**TENNESSEE VALLEY AUTHORITY  
SEQUOYAH NUCLEAR PLANT  
UNITS 1 AND 2**

**ANP-3053(NP), Revision 3, Sequoyah HTP Fuel Transition –  
NRC RAIs and Responses, May 2012  
(Non-Proprietary Version)**

## Sequoyah HTP Fuel Transition – NRC RAIs and Responses

**Figure 4: Updated Core Safety Limit Lines for Sequoyah Technical Specifications**

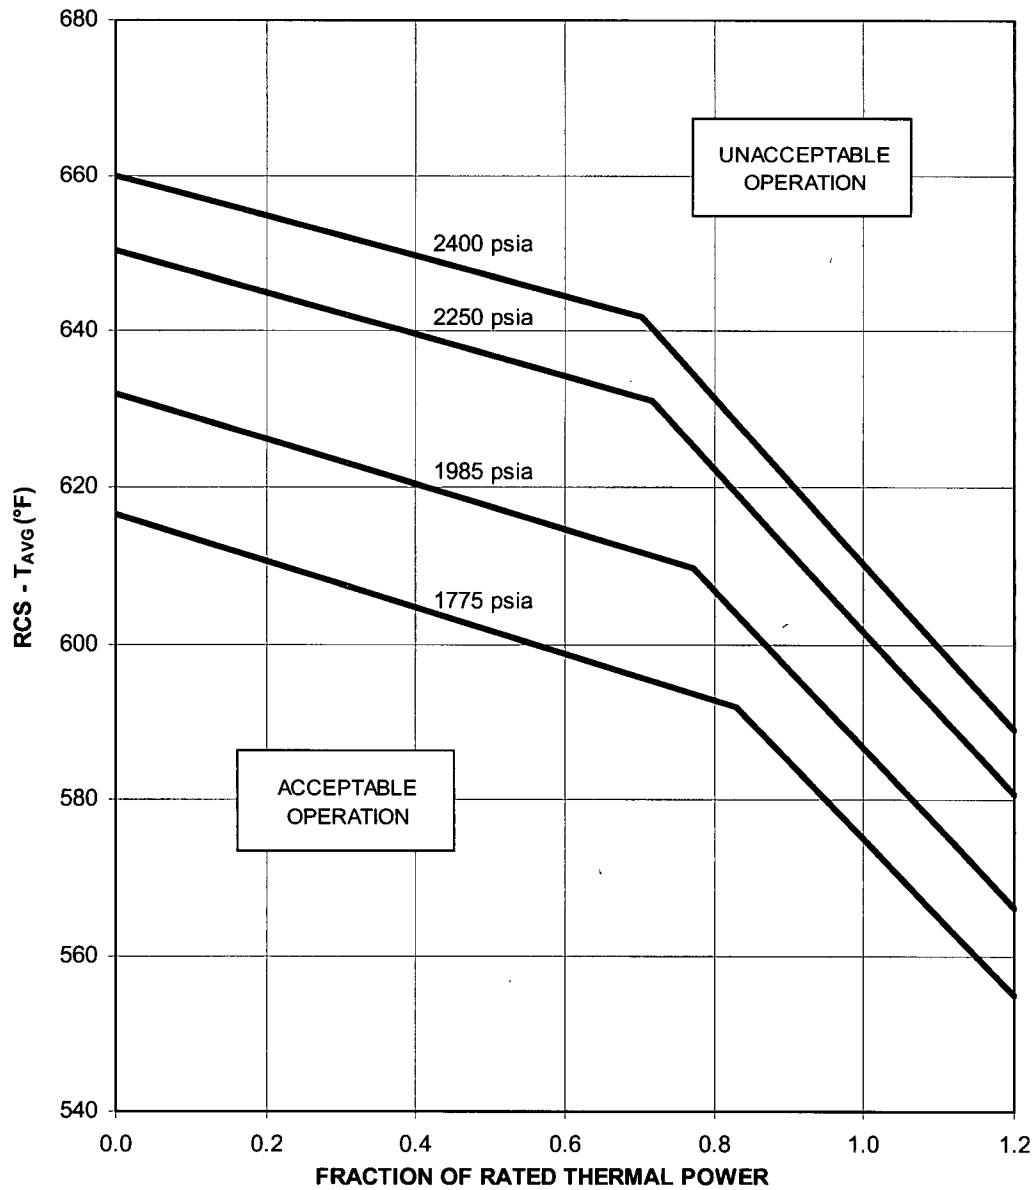
With respect to application of the approved methodologies and proper implementation of the Adv. W17 HTP fuel design, two changes to the previously submitted LAR for use of the HTP fuel design (Reference 4) are required. The first change is related to a revision of the core safety limits and the second change is related to accident analysis validation (specifically, the steam line break coincident with rod withdrawal at power). For consistency with the described changes, the Bases for Reactor Core Safety Limit 2.1 in the SQN Nuclear Plant Technical Specifications was also modified. The modified Bases are provided at the end of this section.

As a result of these changes, the core safety limit lines shown in Figure 2.1-1 of the SQN Units 1 and 2 Technical Specifications will be modified to represent the protected OT $\Delta T$  trip limit lines and are shown in Figure 4 below.

The revised CSL lines generated for the Adv. W17 HTP fuel design at the higher reactor coolant flow rate were evaluated against the Mark-BW CSL lines at the current reactor coolant flow rate, and it was shown that the CSL lines shown in Figure 4 are applicable to both fuel designs resident in the SQN Units 1 and 2 cores. Therefore, Figure 4 is applicable for use in the SQN Units 1 and 2 Technical Specifications.

**Figure 5: Sequoyah Core Safety Limit Comparison for Advanced W17 HTP Transition**

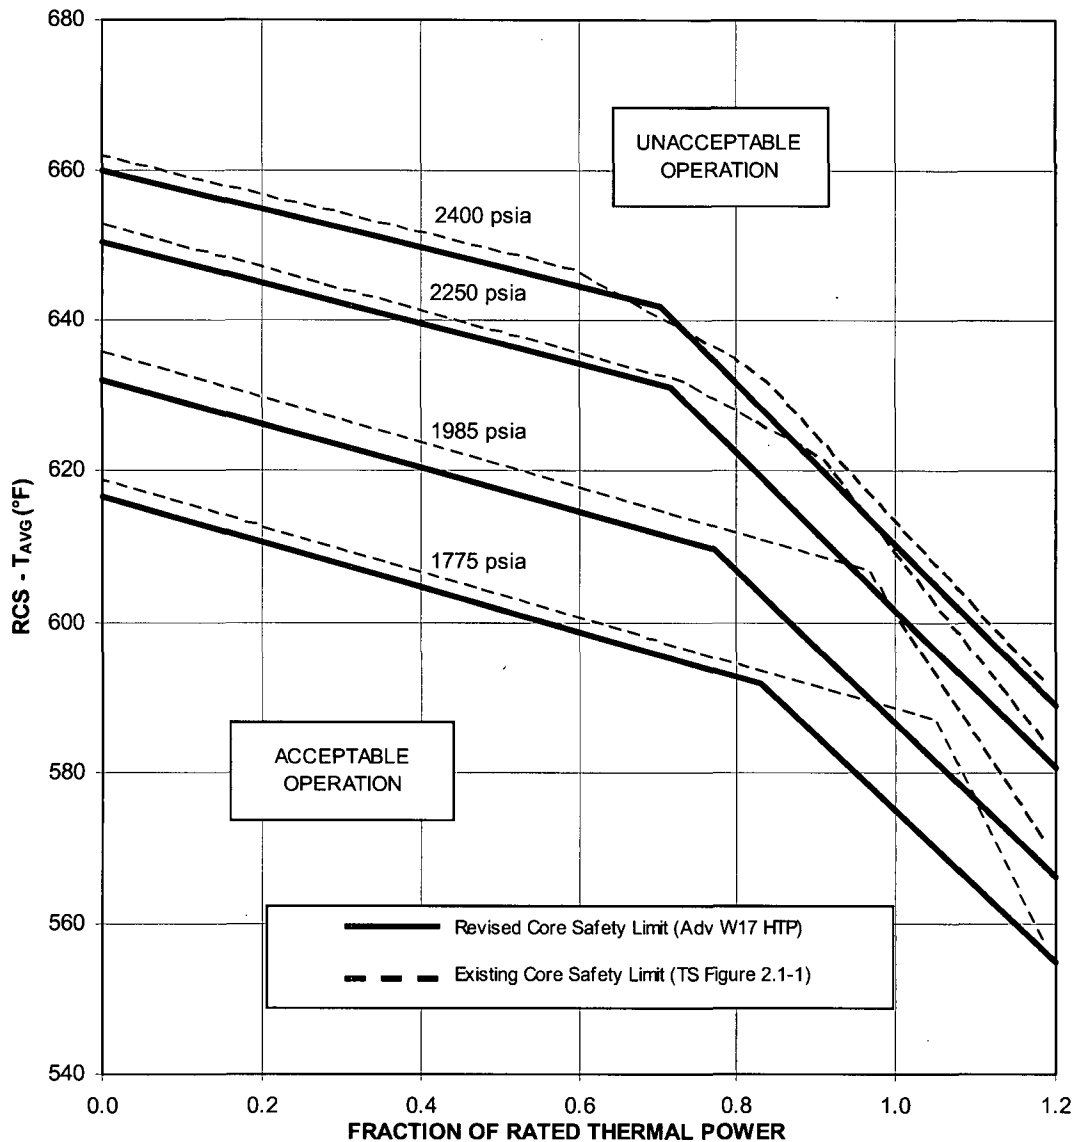
In addition, Figure 4-1 of ANP-2986(P) Revision 3 is replaced by Figure 5, below, which provides a comparison between the CSL lines consistent with the protected OT $\Delta T$  limit lines, with a flow rate of 378,400 gpm, and the current existing Sequoyah TS CSL lines. It is noted that the pressures are not identical for the comparison between the Adv. W17 HTP line (at 1985 psia) and the Sequoyah TS CSL line (at 2000 psia).

Similarly, Figure 1 of the LAR Enclosure should be replaced with Figure 5 below (it should be noted that Figure 1 of the Enclosure is mislabeled, as it refers to Current

Mark-BW versus Proposed Adv. W17 HTP Fuel; the figure is actually a comparison of the existing Technical Specification Figure 2.1-1 to the Proposed Adv. W17 HTP Fuel and does not present the Mark-BW-specific core safety limit lines).

**Note:** This figure replaces Figure 4-1 of ANP-2986(P), Revision 3

**Note:** This figure replaces Figure 1 of the LAR Enclosure
